DUKE ENERGY

GAS DEPARTMENT
 DUKE ENERGY
 ERLANGER DISTRICT N.T.S.

AUTHORIZED
 SEP 25, 2017
 CONSTRUCTION
 DRAWINGS

PROJECT ACTIVITY		BIG BONE		DRAWN	ENE	09-25-17
INSTALLATION	R2190	I		CHECKED	DK/EK	09-25-17
ABANDONMENT	R2190	X		APPROVED	JP	
RENEW SERVICE M-C	MCNEWPI0	I		CLOSED BY		
RENEW SERVICE C-M	CMNEWPI0	I		EST. FOOTAGE	50749'	
RELOCATE METER	GMSMOVE	X				
MAP NO. S 0 5 W 0 2 - 4 7		DRAWING NO. 8 2 0 5 8 0 4

8
54

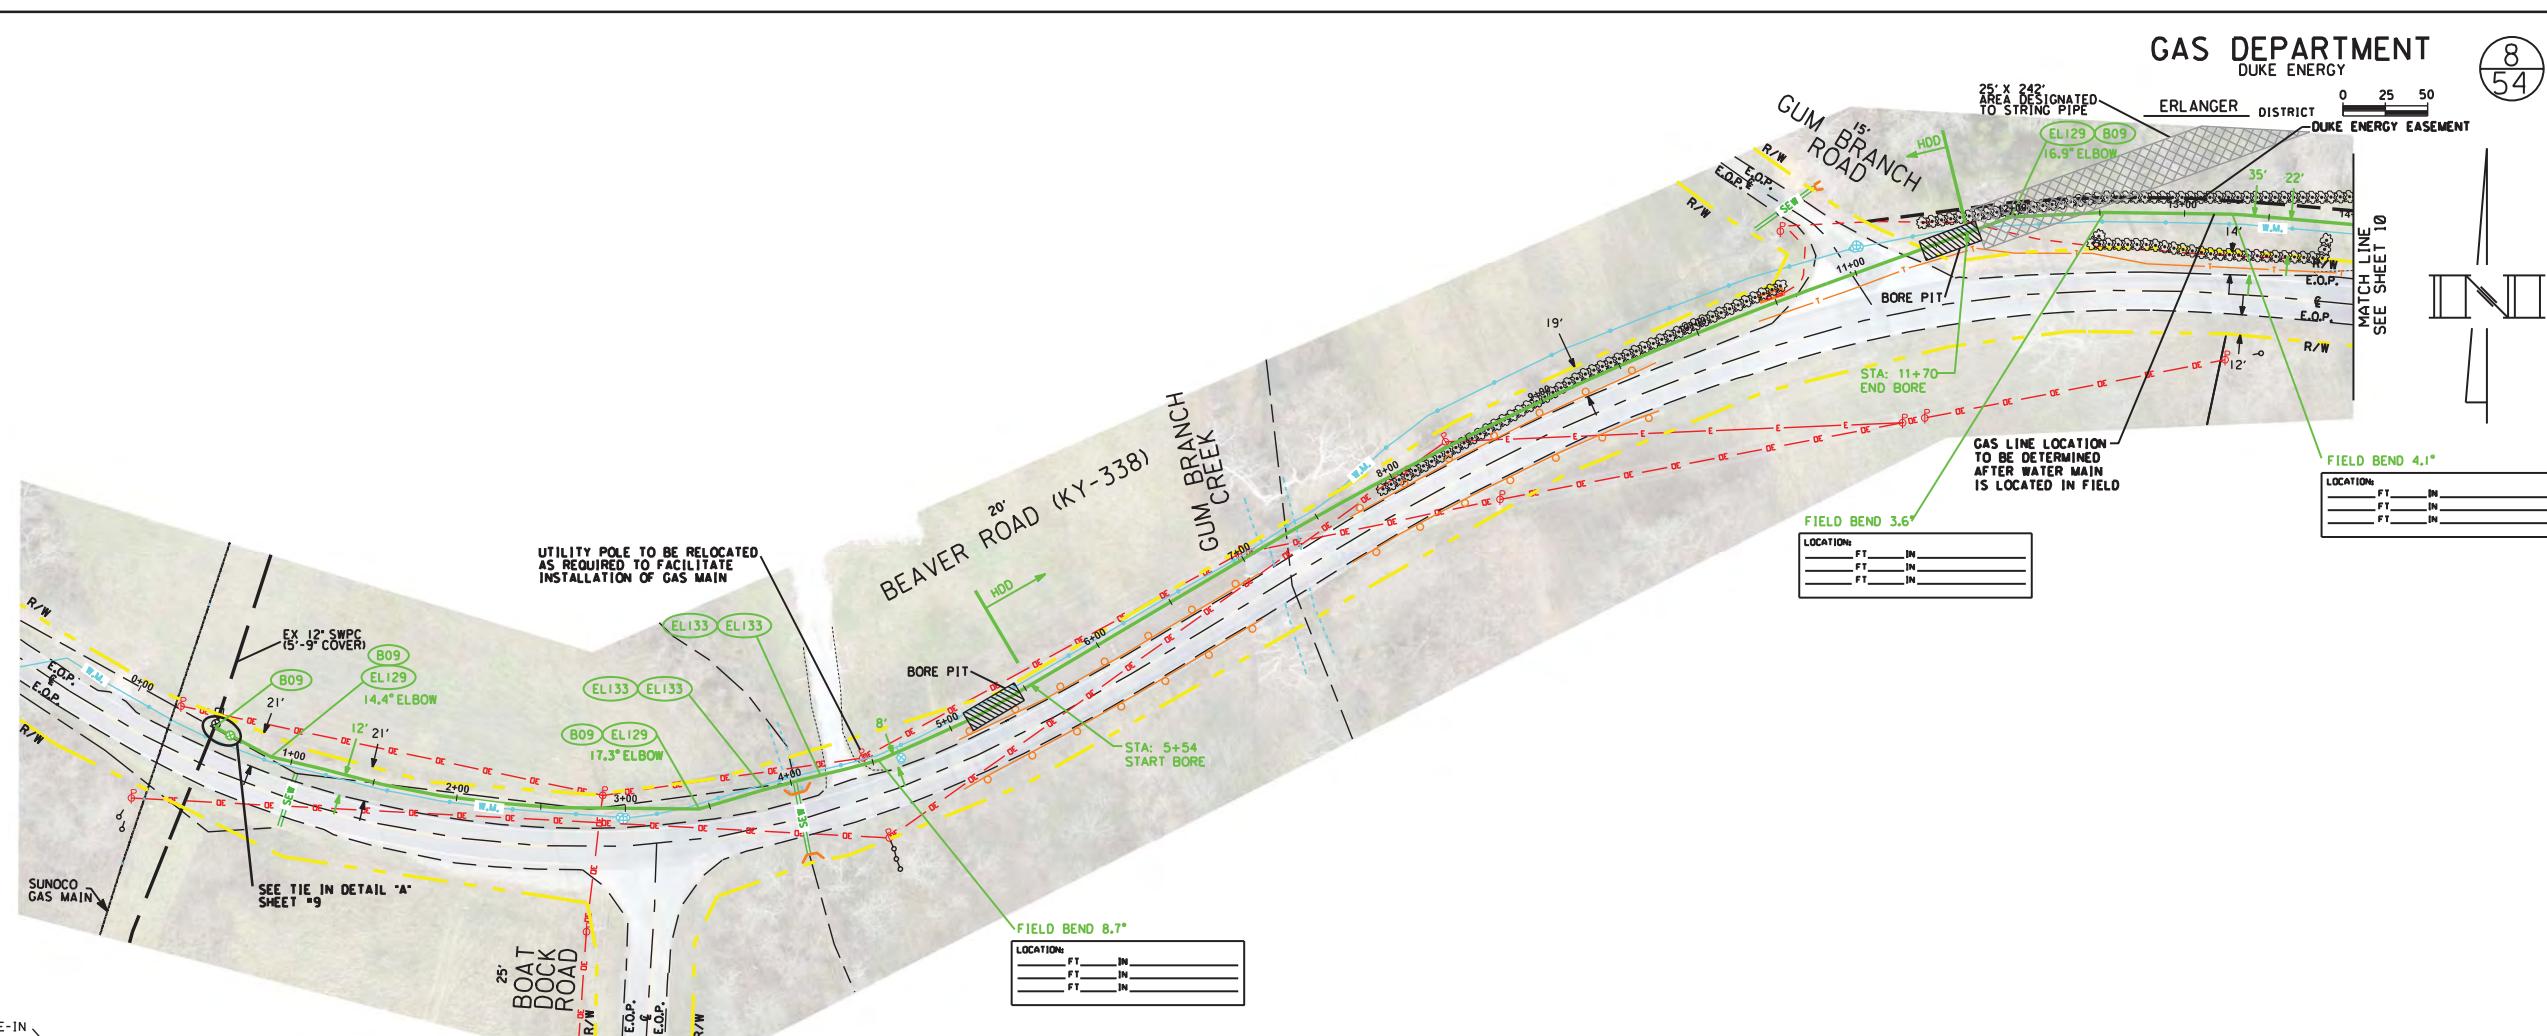
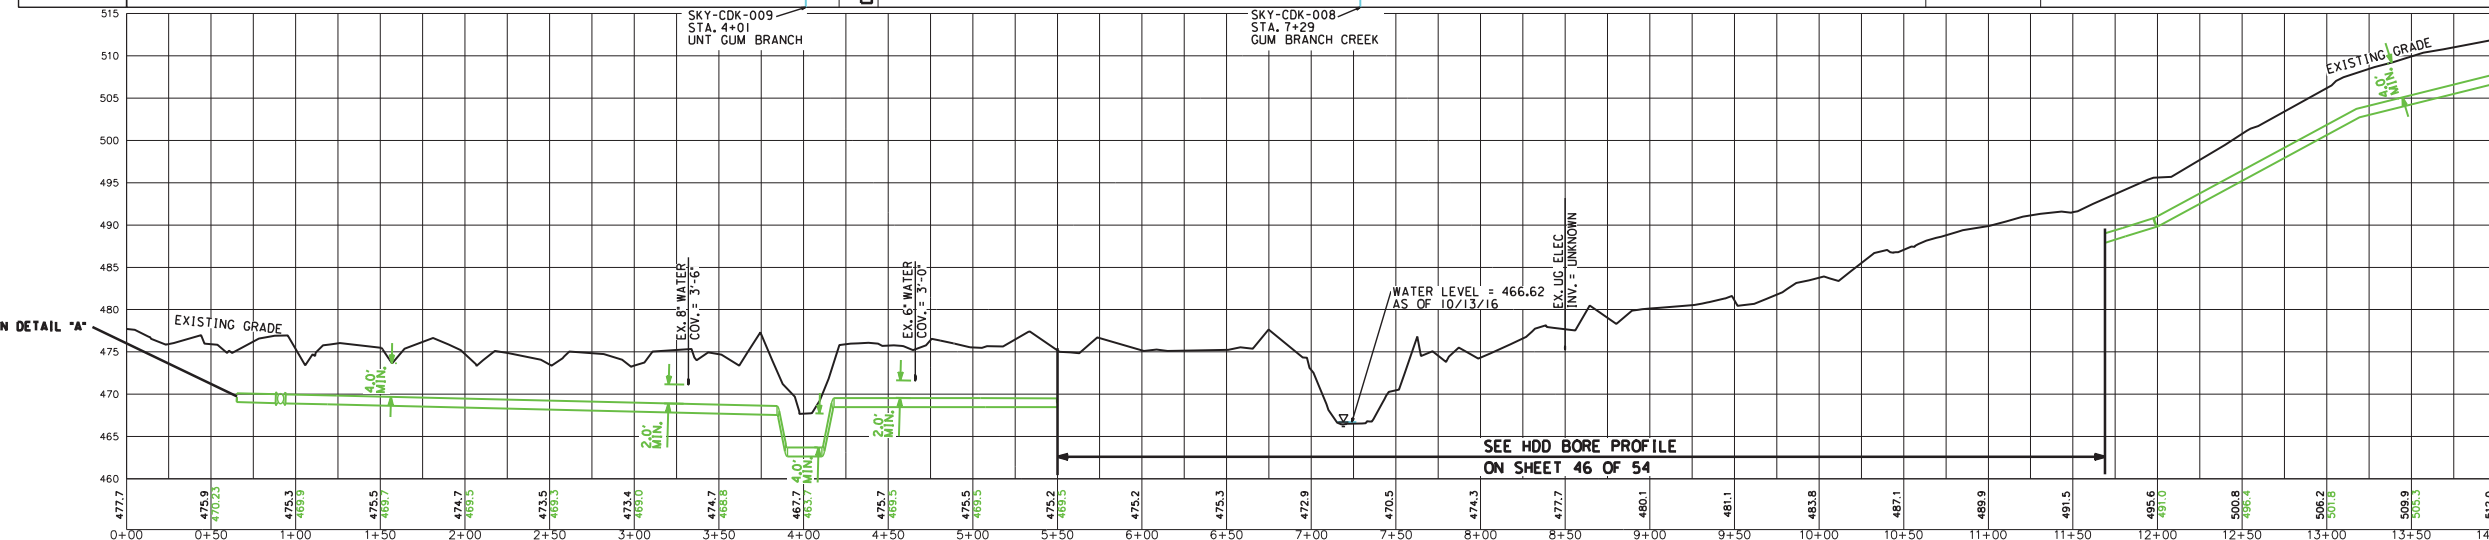
REVISION 2: UPDATED RUNNING LINE PER WATER LOCATE EAST OF GUM BRANCH ROAD.

DETAIL "A"
N.T.S.
(FROM SHEET 8)

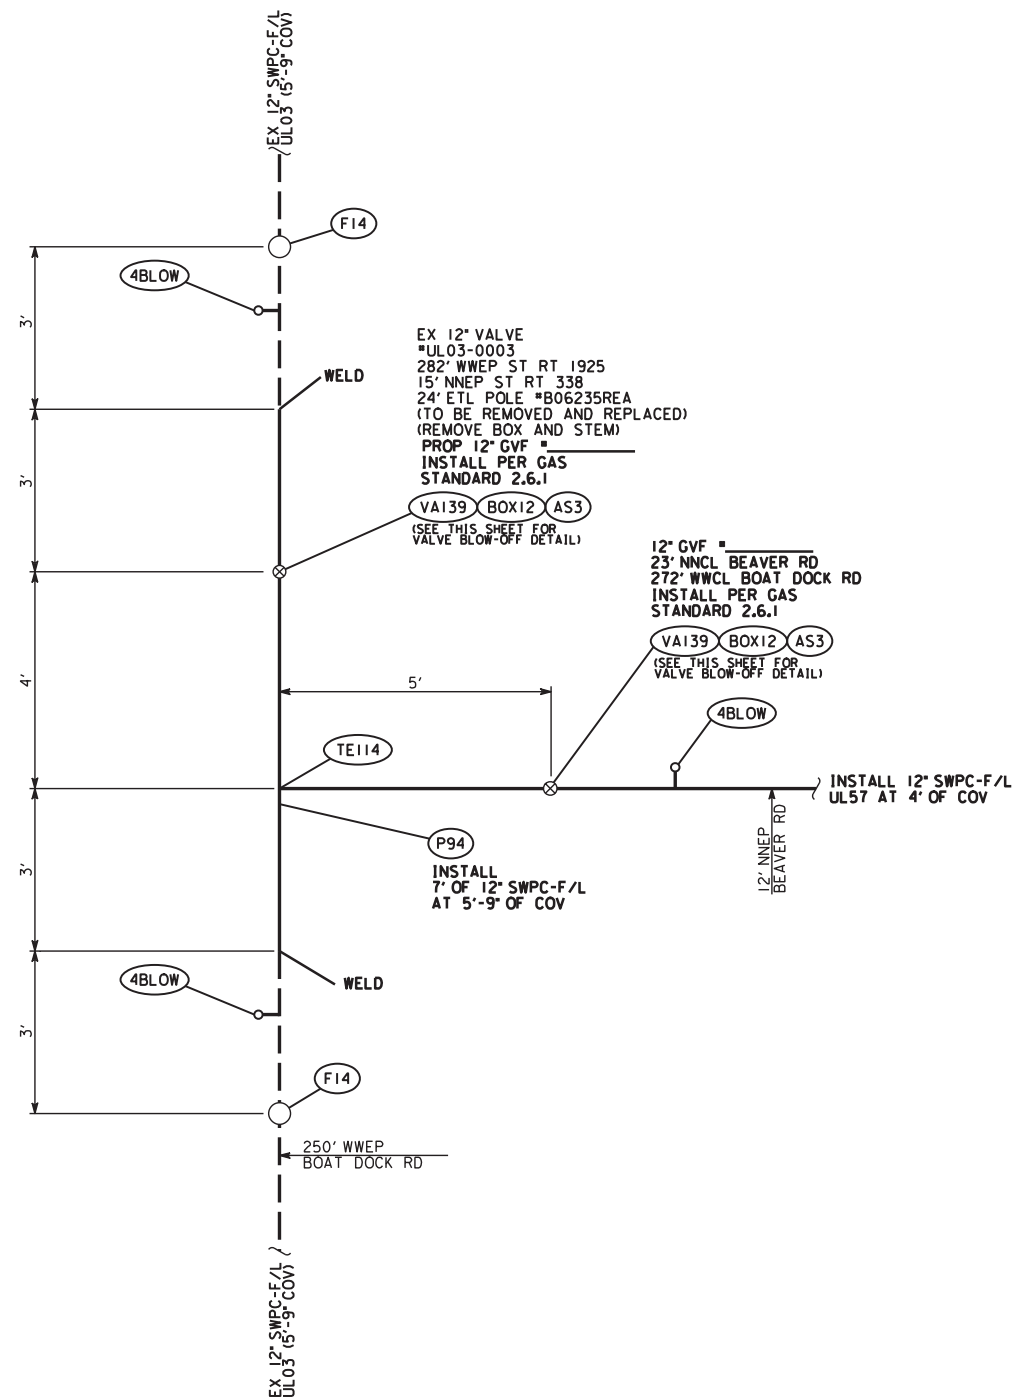
REVISION 1: REMOVED BOM FOR VALVE BLOW-OFF.

10
54

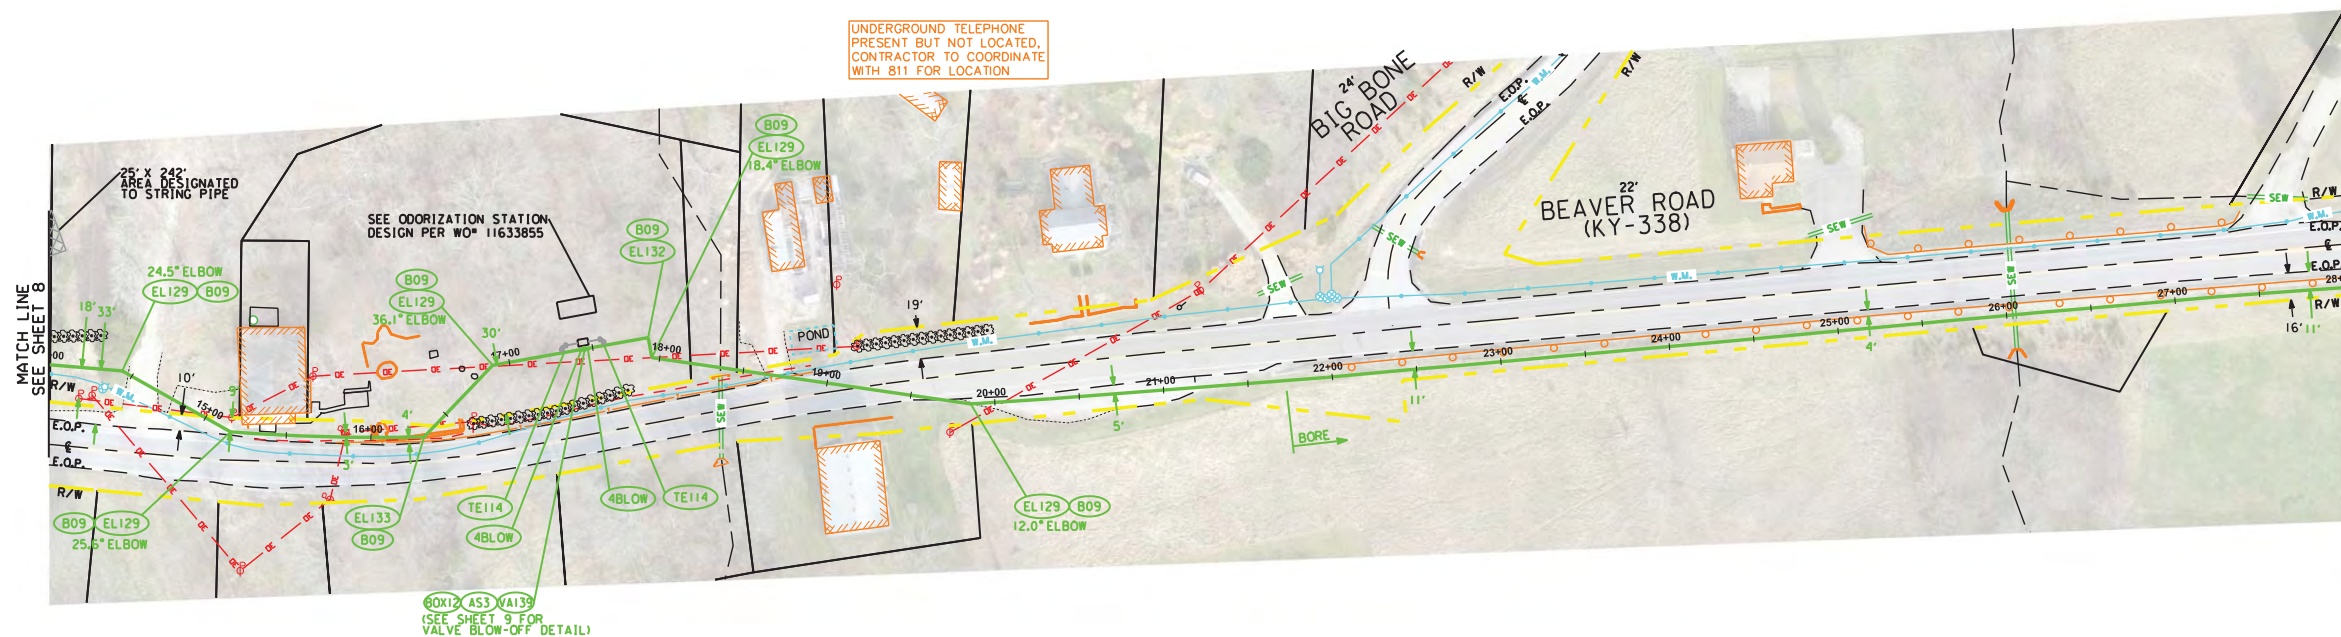
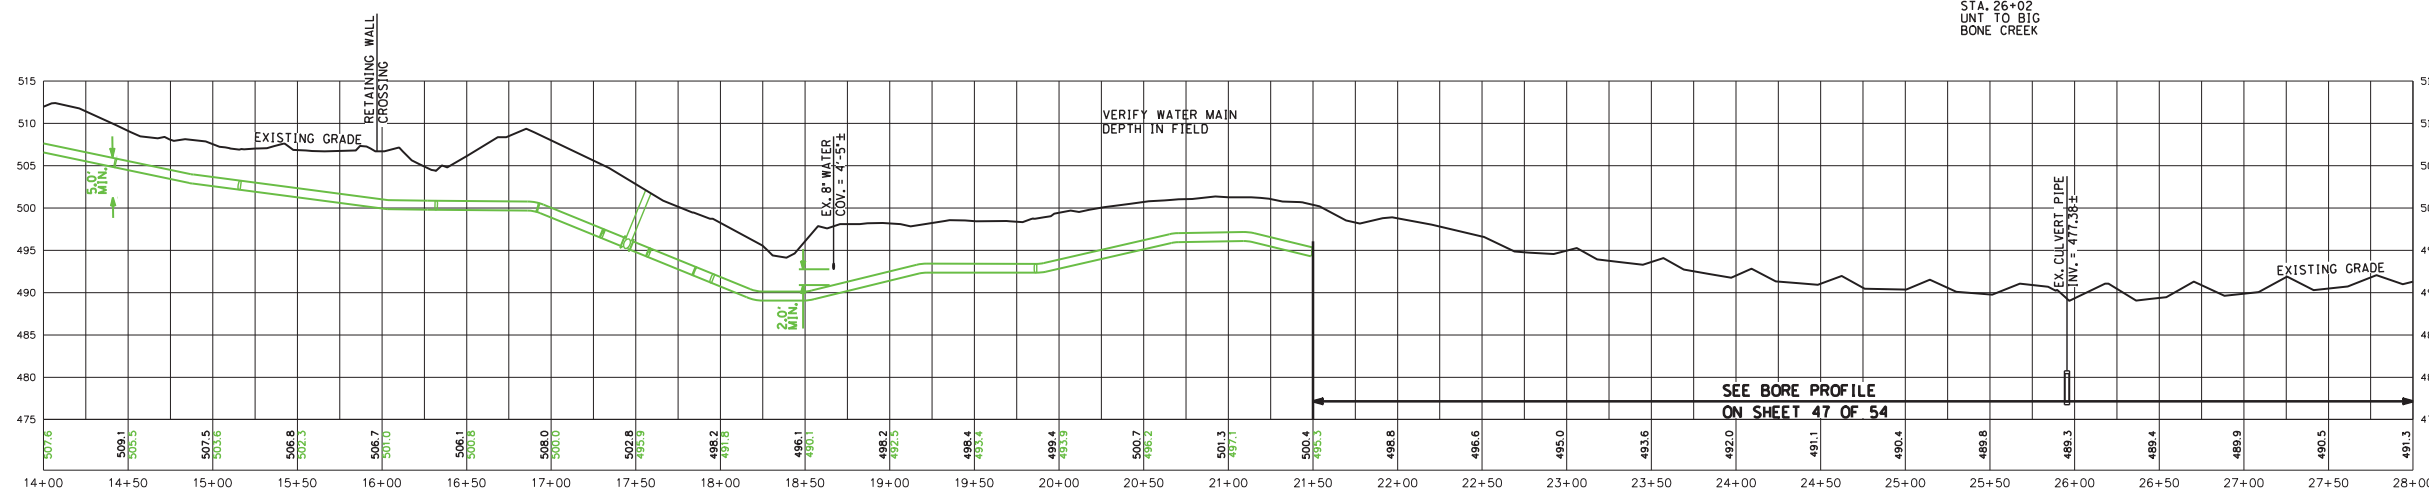
REVISION 2: UPDATED RUNNING LINE AT ODORIZER FOR ROAD CROSSING.
 REVISION 1: CHANGED CROSSING AT STA 20+00 FROM BORE TO OPEN CUT.

14
54

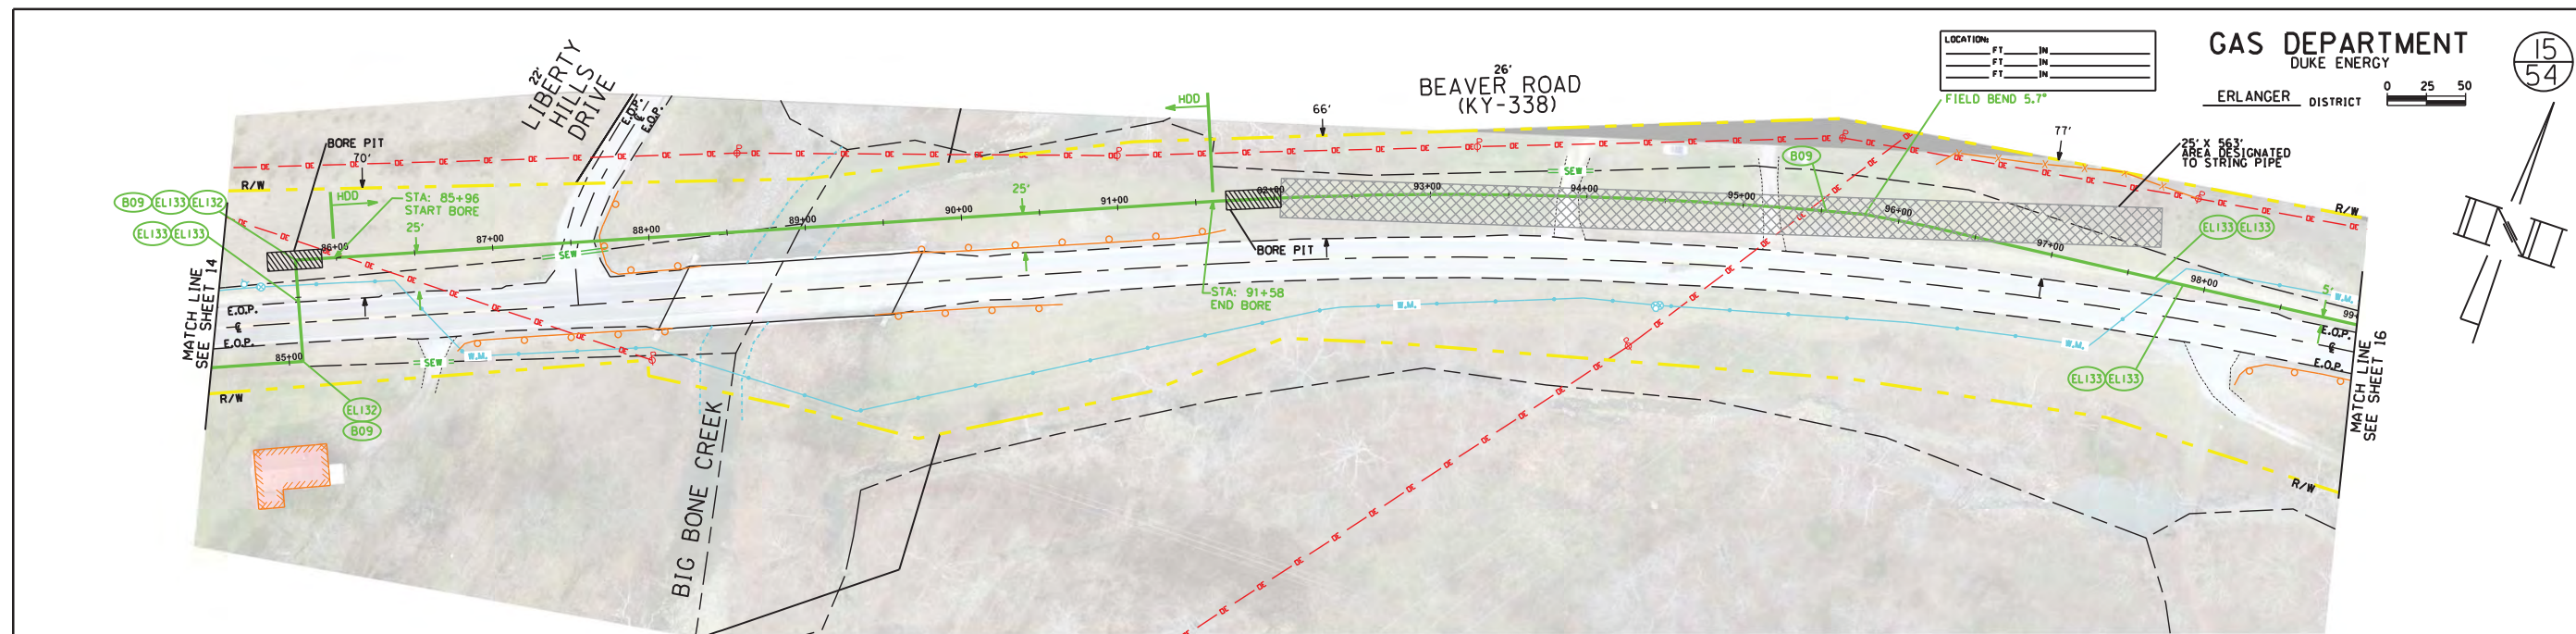
REVISION 1: CHANGED CROSSING AT STA 74+40 FROM BORE TO OPEN CUT.

20
54

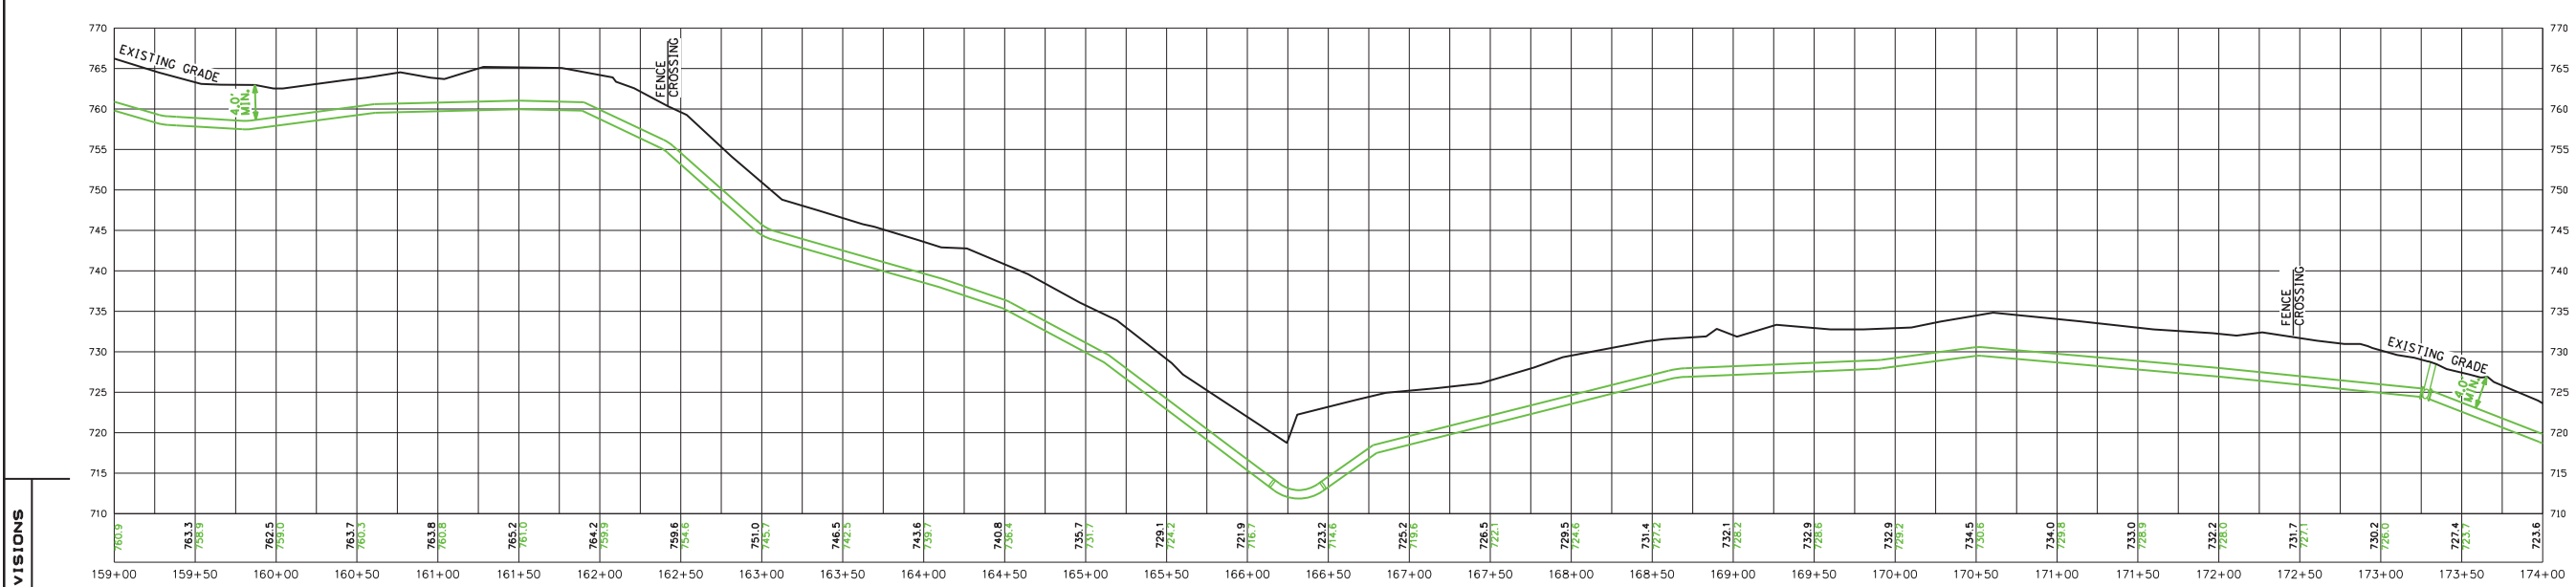
REVISION 1: VALVE RELOCATION FROM SHT 21 TO SHT 20.
